Engineers Comments Regarding Surface Water Drainage

Application Reference:	AB/134/25/DOC	Reviewer Reference:	ADC/EXT3/RW
Planning Officer:	Kathryn Welch	Date of Review:	06/05/2026
Site Name:	Arundel Gate Ford Road Arundel		
Application Description:	Approval of details reserved by condition imposed under AB/135/20/OUT relating to condition 26-as built drawings of approved surface water drainage scheme, for phase 1 and 2 only except plots 13, 17, 19, 20, 44 and 45.		
Assessment Number:	2 of 2

Application Reference: AB/134/25/DOC Site Name: Arundel Gate Ford Road Arundel	Initial Issue Date: 27/01/2026 Issue Date: 06/05/2026 Reviewer Reference: ADC/EXT3/RW
---	---

Drawing Title:
As Built Drawing

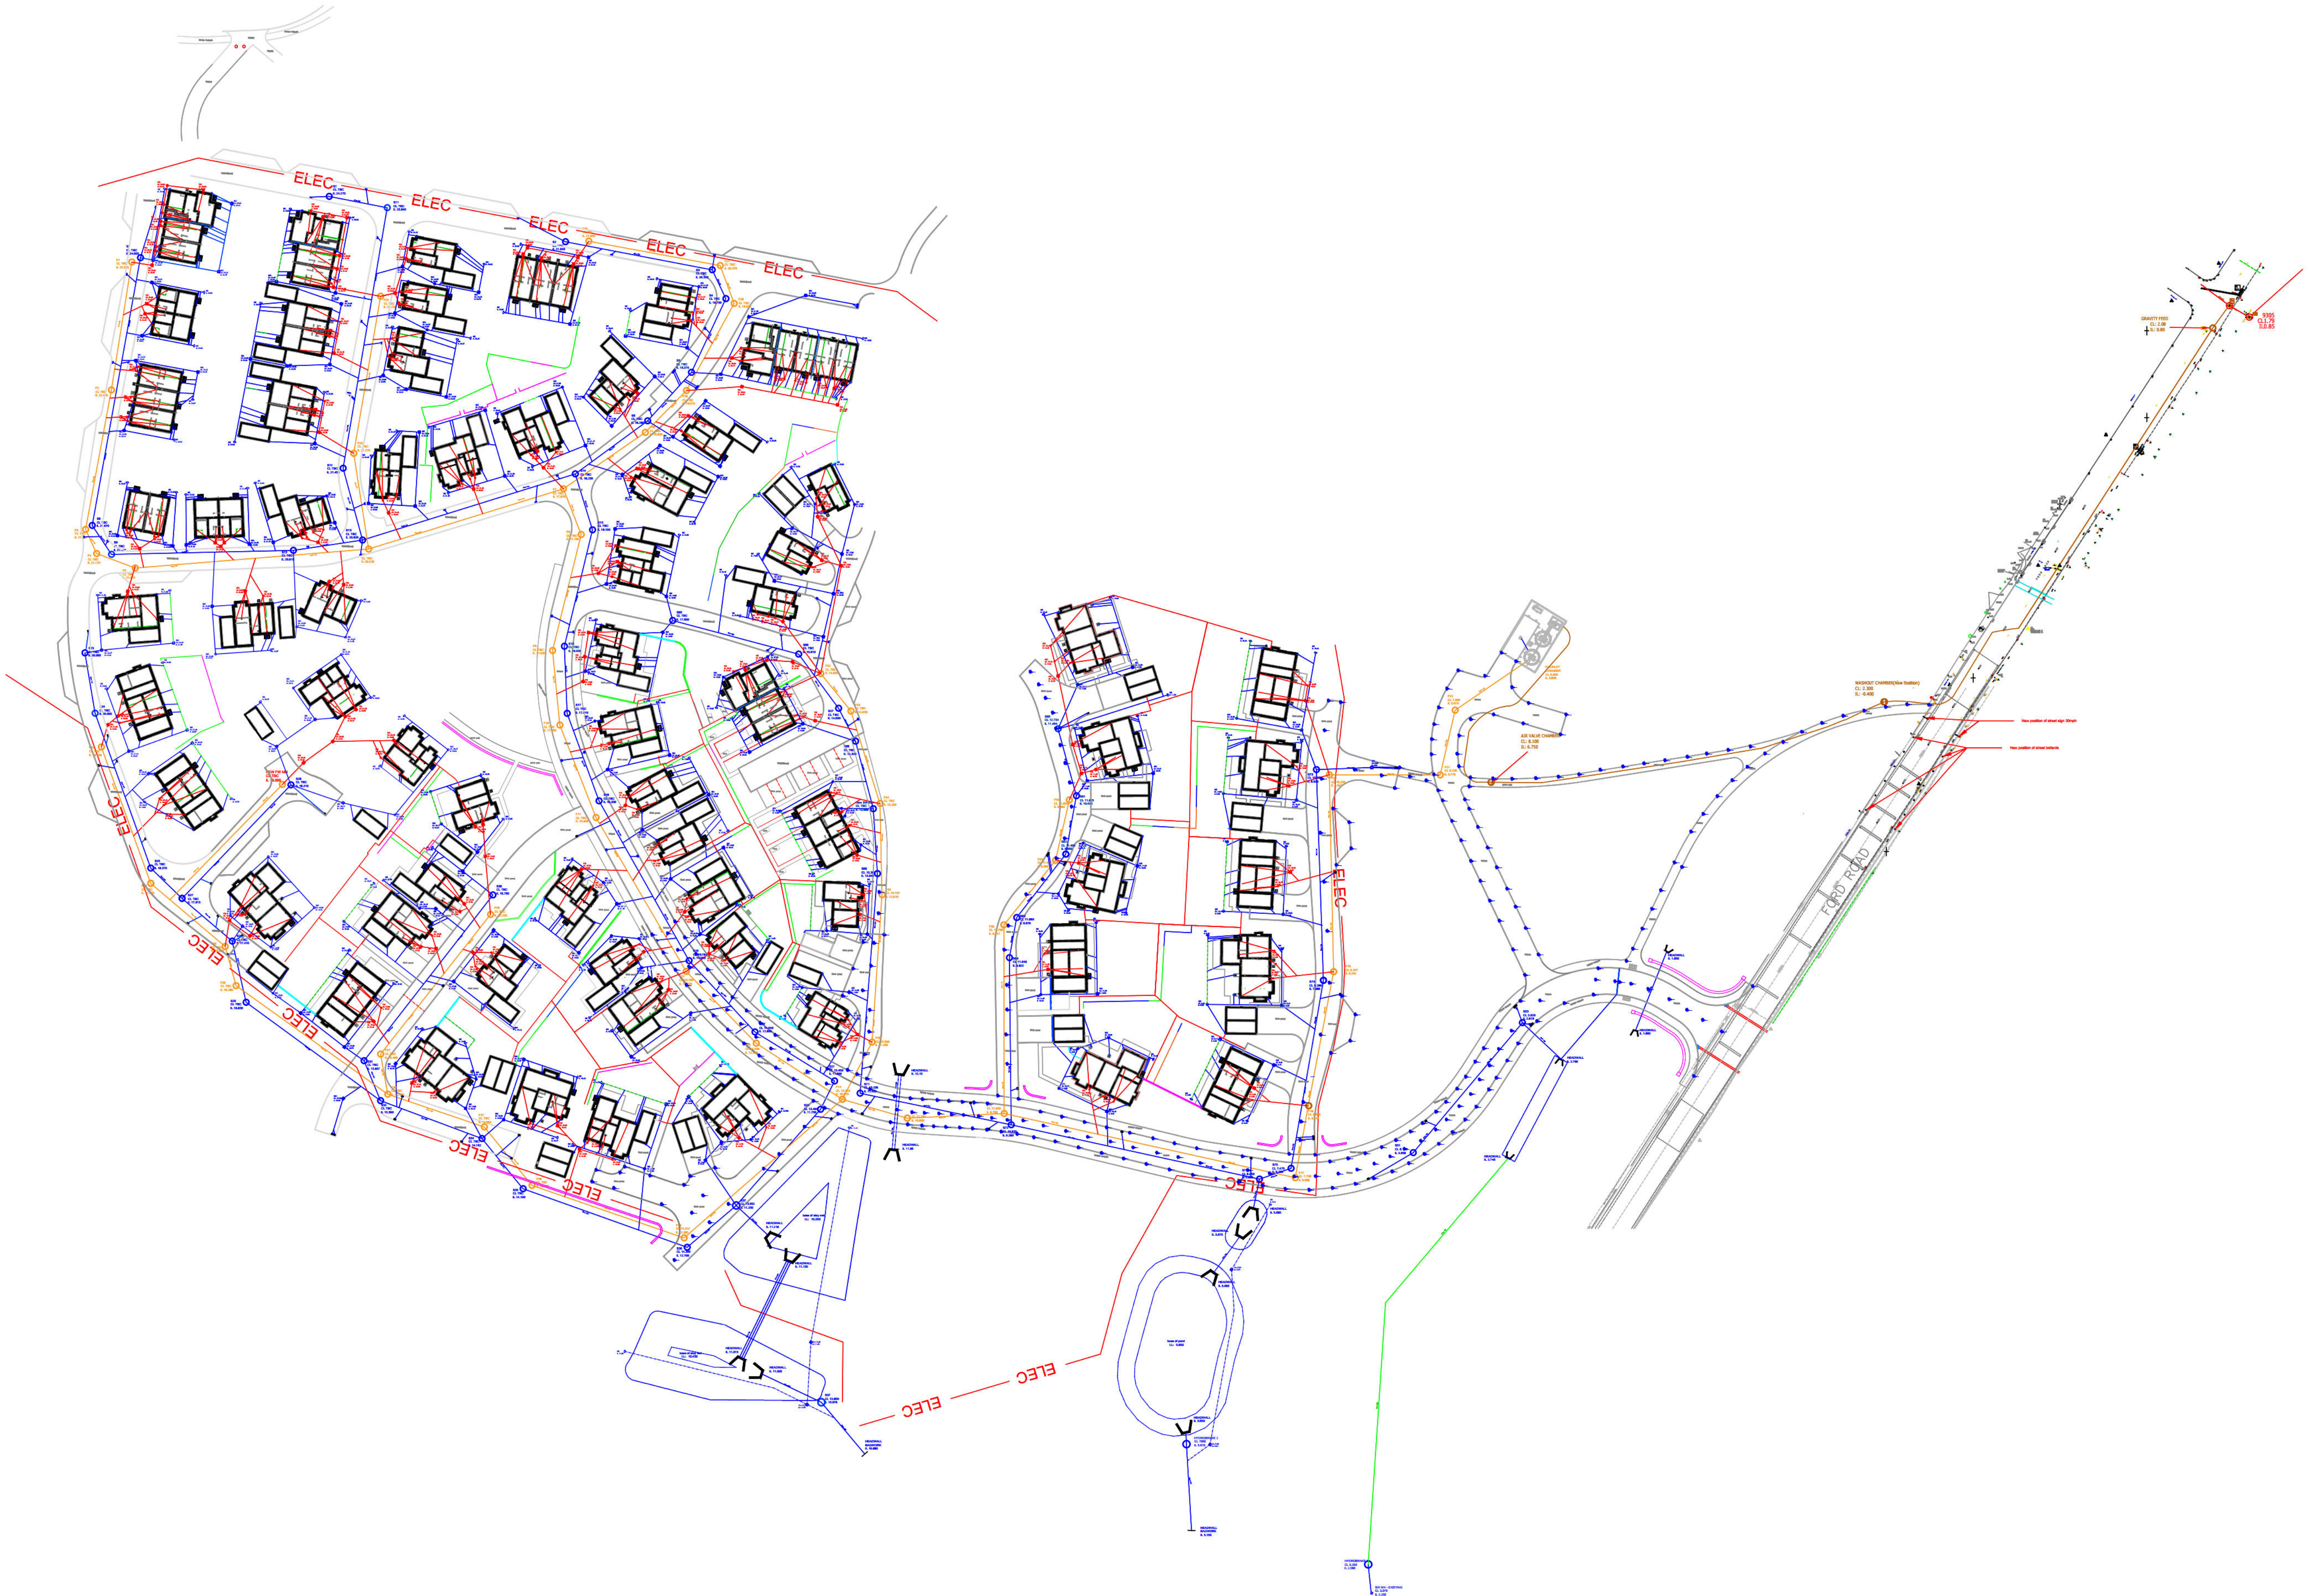
ADC Drainage Comments	Designer Response			
Date:	27/01/2026				
Condition Number: 26					
Comment Number					
1.	As built survey provided is low resolution and cannot be validated, can the as built survey be provided in useable format. As built survey to include finished surface levels of all hard landscaped areas including all private drives and FFLs for all plots. All gullies must be shown including yard gullies and linear drainage channels All pipes and manhole locations including pipe and manhole invert and diameter		A mark up of the as built information has been included showing unexplained discrepancies from the proposed construction information provided: Plots 1-10: no driveway levels shown to show the water drains effectively to the proposed drainage. Attenuation Pond and swale by hydrobrake 2: Pond crest level and swale crest level and location as built required including maintenance strip width. Headwalls built to different levels compared to proposed, does this effect hydraulic modelling? Plot 11: Gulley shown on construction layout not shown on as built.

Base levels and crest levels of SuDS features at reasonable intervals		Plot 25: gulley shown on construction layout not present on as built. Plot 27 – 30: Linear drainage channel in shared car park not constructed. Road levels not shown. Plot 23 and further up main road: No as built levels present. 14- 16: road contours show camber but gulleys only on 1 side. No gulley on plot 15 driveway. No as built road information in further plots.

2.	CCTV survey of constructed drains required.		No CCTV survey provided		
3.	Can the designer confirm that drainage built was constructed in accordance with standard tolerances, please providing reference to the tolerance ranges required.		Further justification required for the statement “ As-Built Survey provided is generally in accordance with the Drainage Strategy with the minor differences in inverts not making a practical difference to the functionality of the system. “ from report.

4.	Can test certificates be provided for membranes		No test certificates provided		
5.	Can construction evidence be provided for items missing		Items still listed as “to be installed. Still in abeyance”

from the design as noted in the report i.e. yard gullies.				
6.	Please provide evidence of liners installed as part of phase 1 and any additional required liners		No evidence of liners or certificates		
7.	If invert levels do not match the proposed drainage, updated calculations or justification that the drainage has been constructed in accordance with the specification		No updated calculations provided for discrepancies.		
8.	Report notes that the pipe installed at access junction as phase 1 was constructed at 300Ø as opposed to 450Ø in design. Can justification be provided.		It is noted the pipe is reduced in diameter to allow for greater depth to cover. Justification of hydraulic analysis not provided.
